Tolerance (Except as noted)	 <b>Memory Protection Devices, Inc</b> 200 Broad Hollow Road, Farmingdale, New York 11735		
decimal ±.5 (.020)		Scale	Drawn By B.S.
Fractional ± .8 (.030)	Title 1159-16 i-BUTTON THRU HOLE RETAINER		
Angular ± 3°	Date 06/21/23	Drawing Number BK-5010

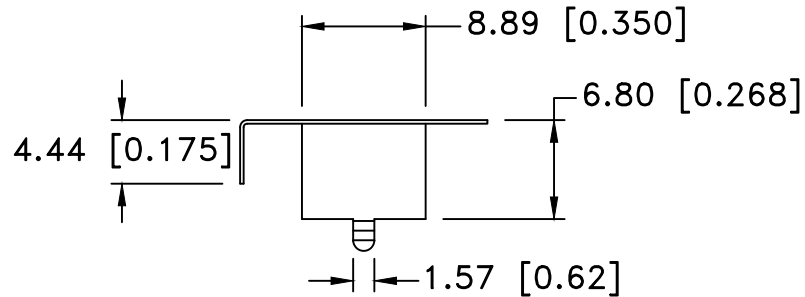
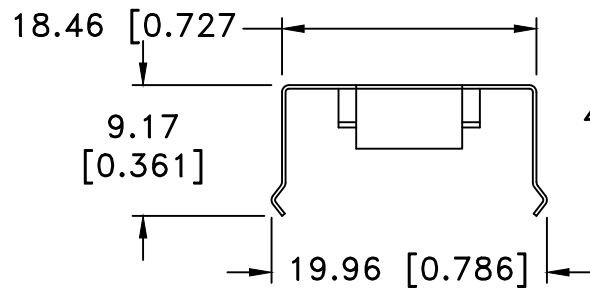
Date	SYM	REVISION RECORD	AUTH	DR.	CK.
12/12/19	D	Added weight of the part	T.B.	B.S.	
06/21/23	E	Dim. 17.57 was 17.78 Dim. 18.46 was 18.29 Dim. 9.17 was 9.40 Dim. 19.96 was 19.80 Dim. 4.44 was 4.57 Dim. 6.80 was 7.11 Dim. 1.57 was 1.52	T.B.	B.S.
